Contract No. 22221 PF0
Fullerton Fire Station #8 Renovations & Addition
(4401 Fitch Avenue, Nottingham, Maryland 21236)
Nottingham – District 14c5
Workday No. 200540012

ADDENDUM NO. 3

DATE: 12/20/2024

PROJECT:	Fullerton Fire Station #8 – Renovation & Addition	MWS PROJECT NO:	20-120
ADDRESS:	4401 Fitch Avenue Nottingham, Maryland, 21236	CONTRACT NO.	22221 PF0
		ISSUE DATE:	December 19, 2024

1 FIRST FLOOR PLAN
1/8" = 1'-0"

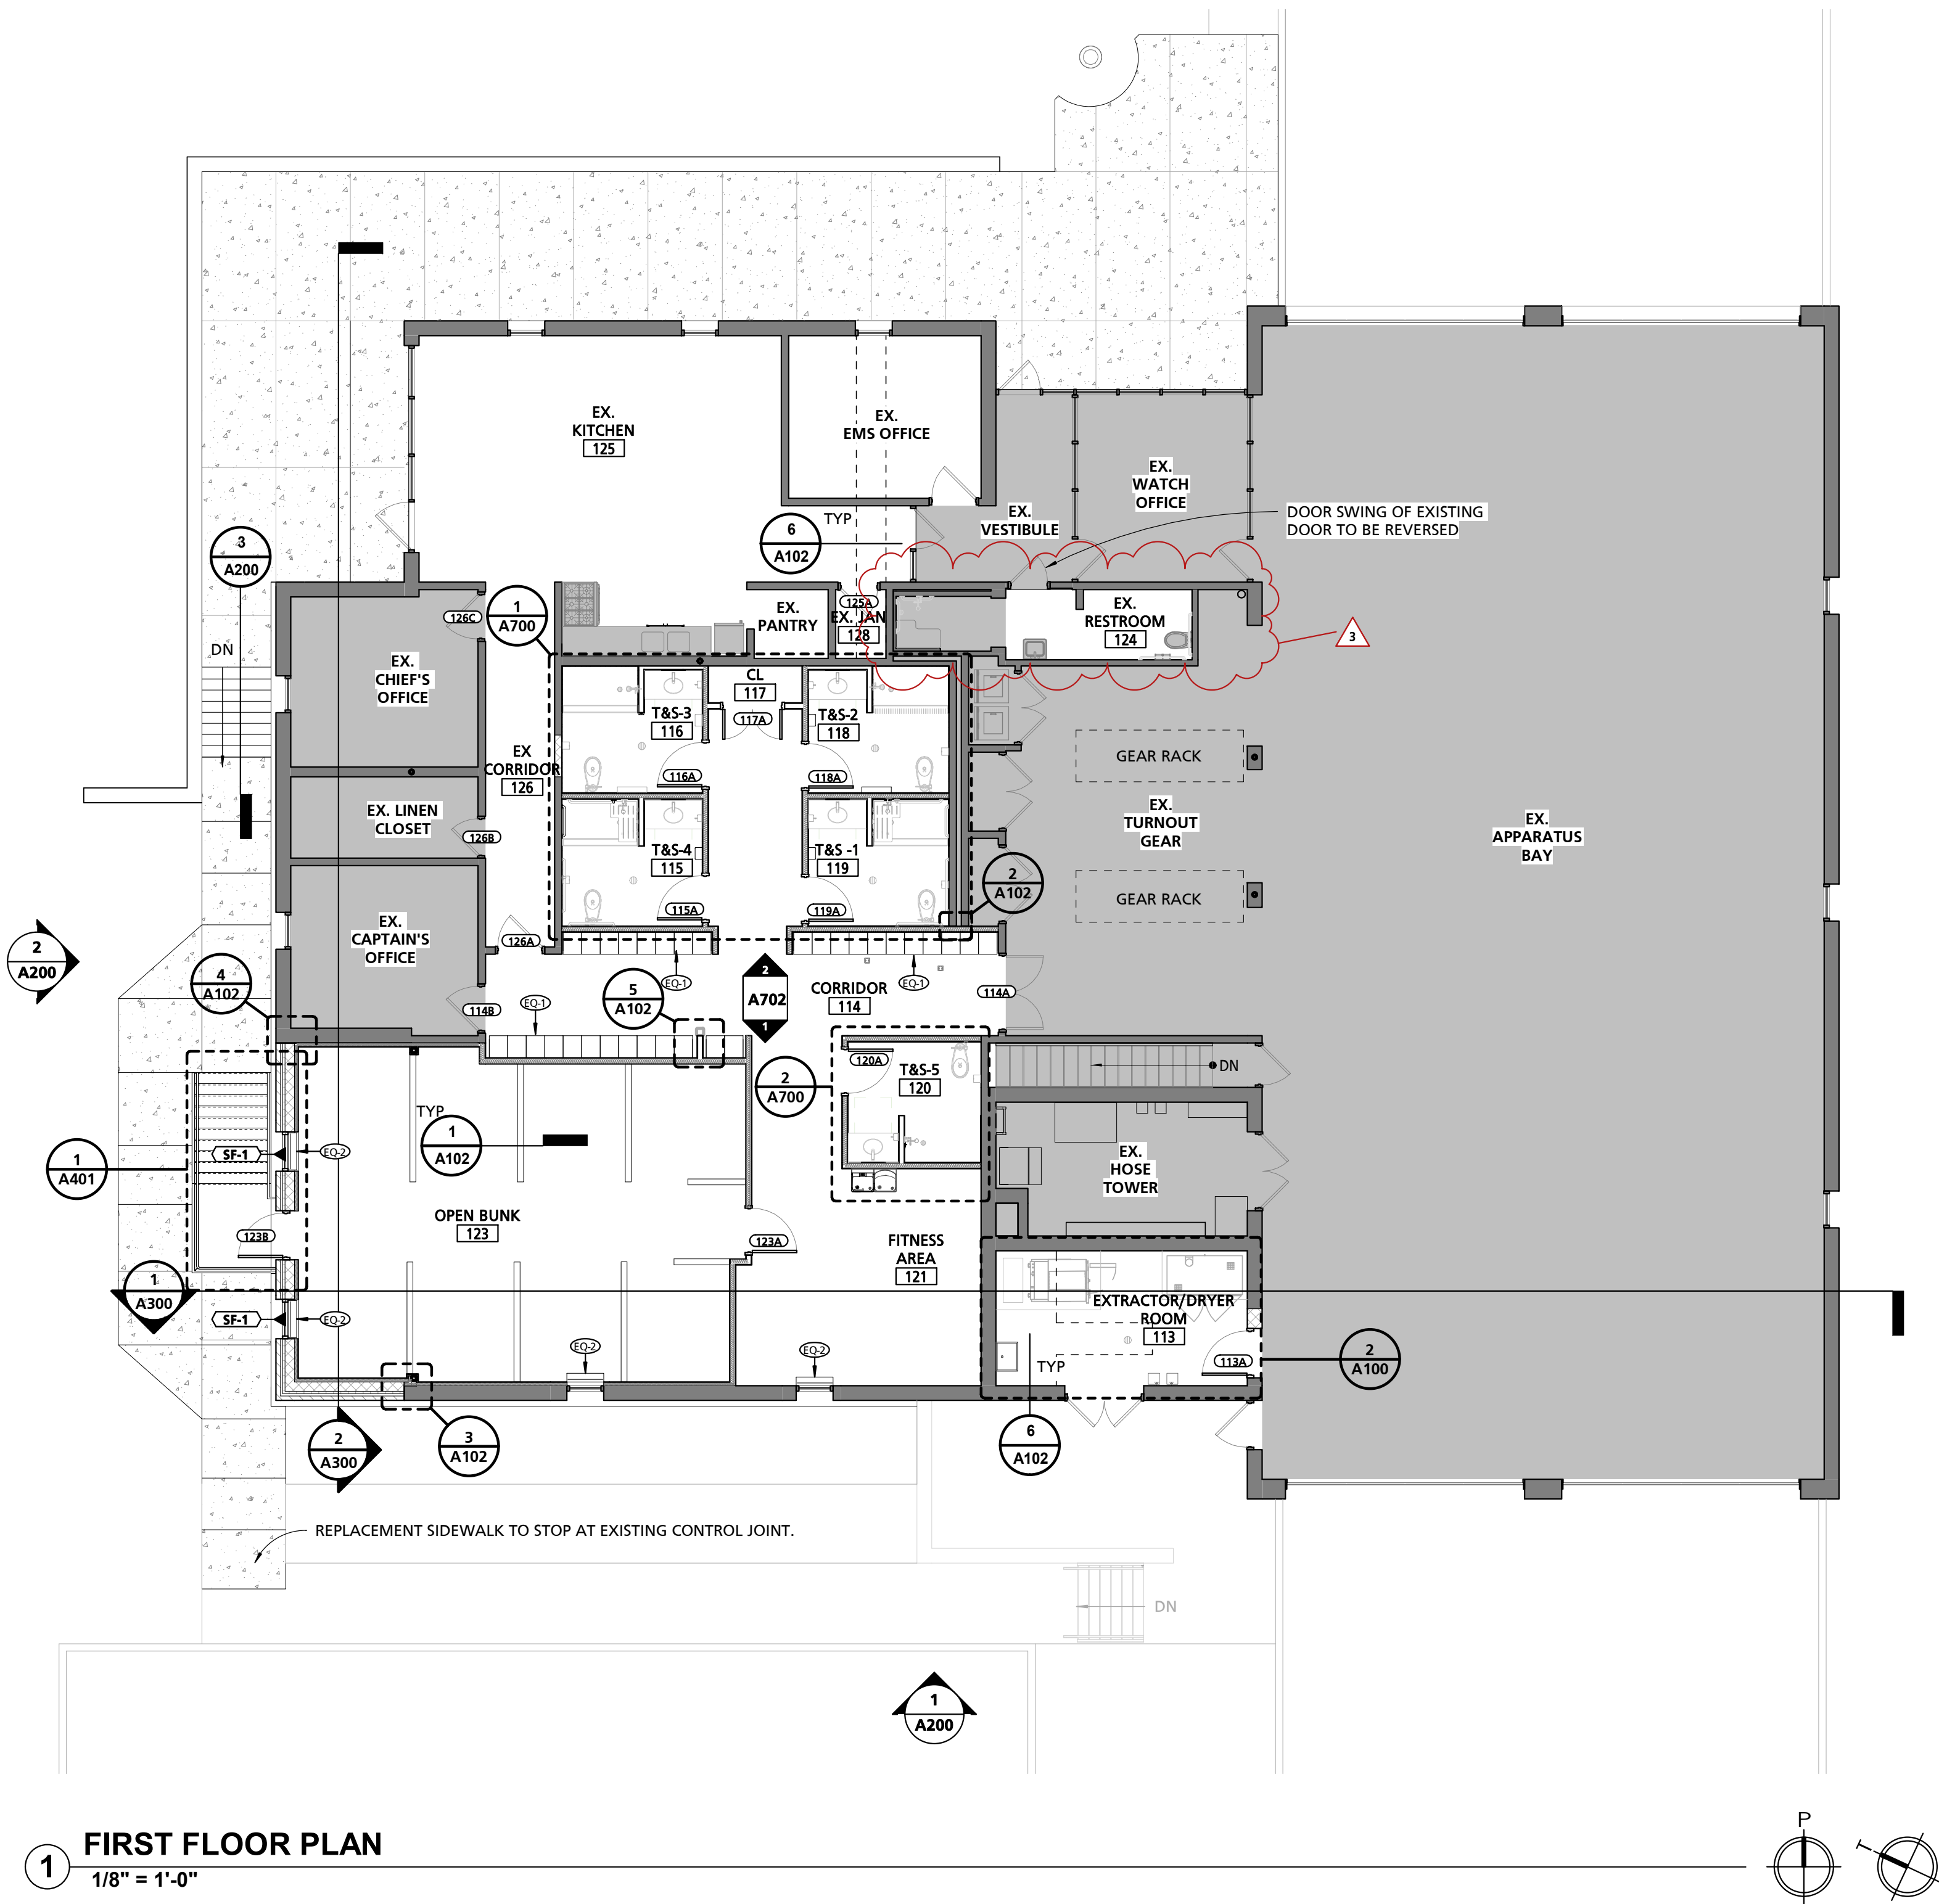
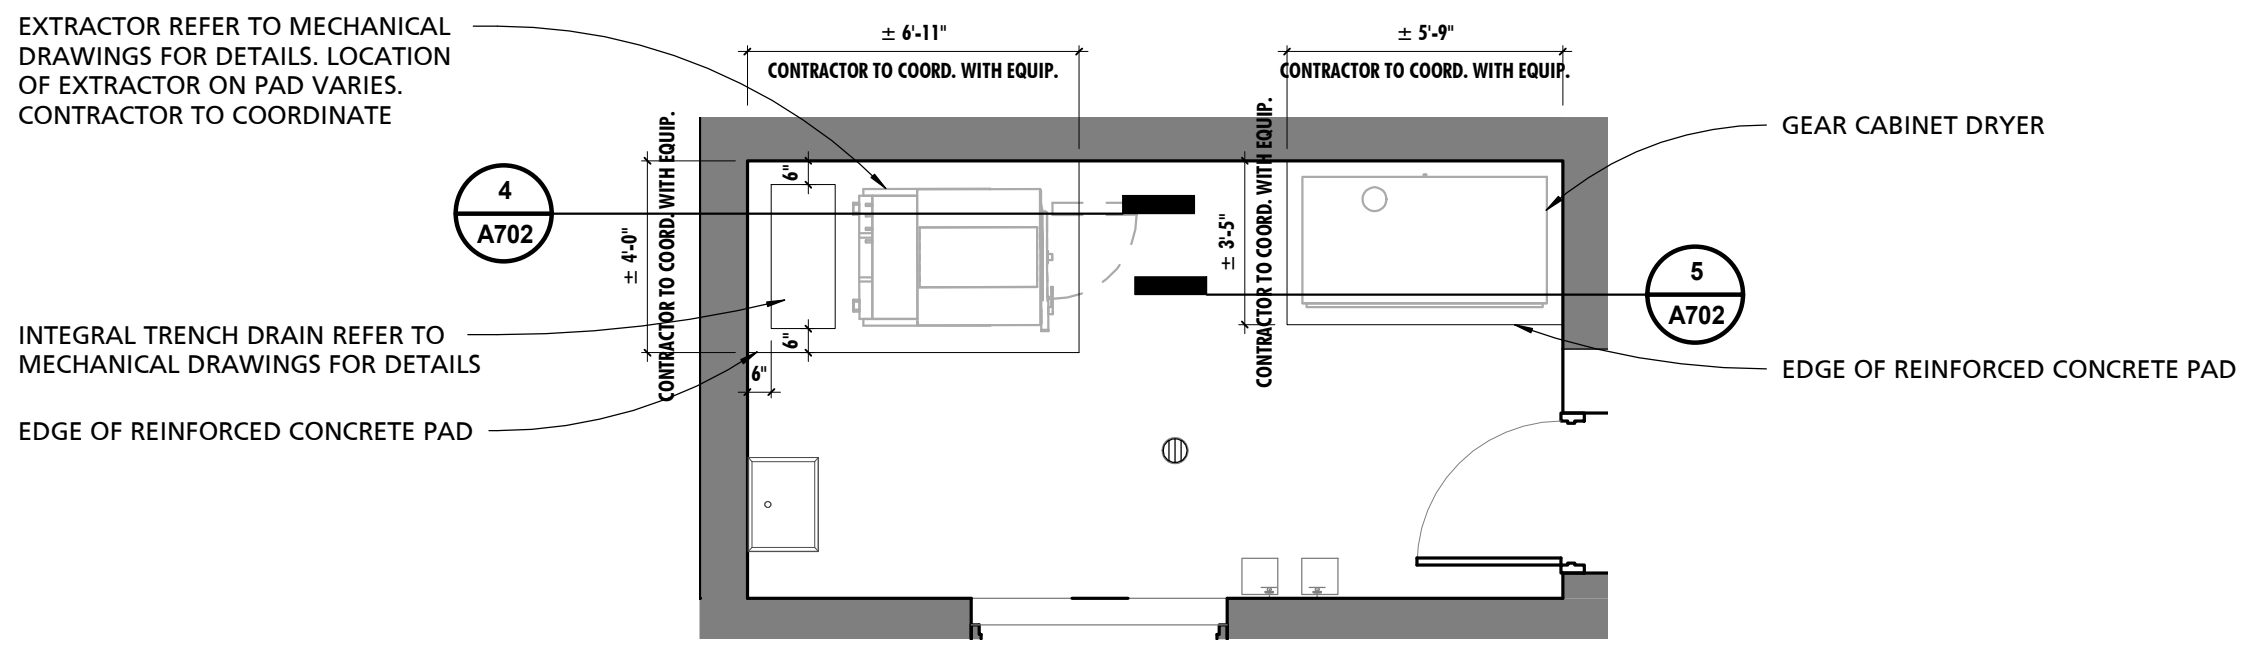
30.)QUESTION: Roller Shades are called out for on the Equipment Schedule on Drawing Sheet A702 and accounted for on sheet A100. However, other than the details on the equipment schedule, the shades are not listed anywhere in the spec manual. Can you please confirm if GC is to provide these shades, and if so, are there any further specs you can provide?

31.)QUESTION: About the finish schedule... It shows 124 getting the resinous flooring treatment, but that room is shaded dark grey meaning it is not in scope. Can you confirm whether this room is to be included?

RESPONSE: The roller shades per the equipment schedule are contractor provided, contractor installed. Provide BOD Hunter Douglas RB-500.

RESPONSE: Room 124 shall receive resinous flooring per the finish schedule. See amended drawing A100, A102, and A103.
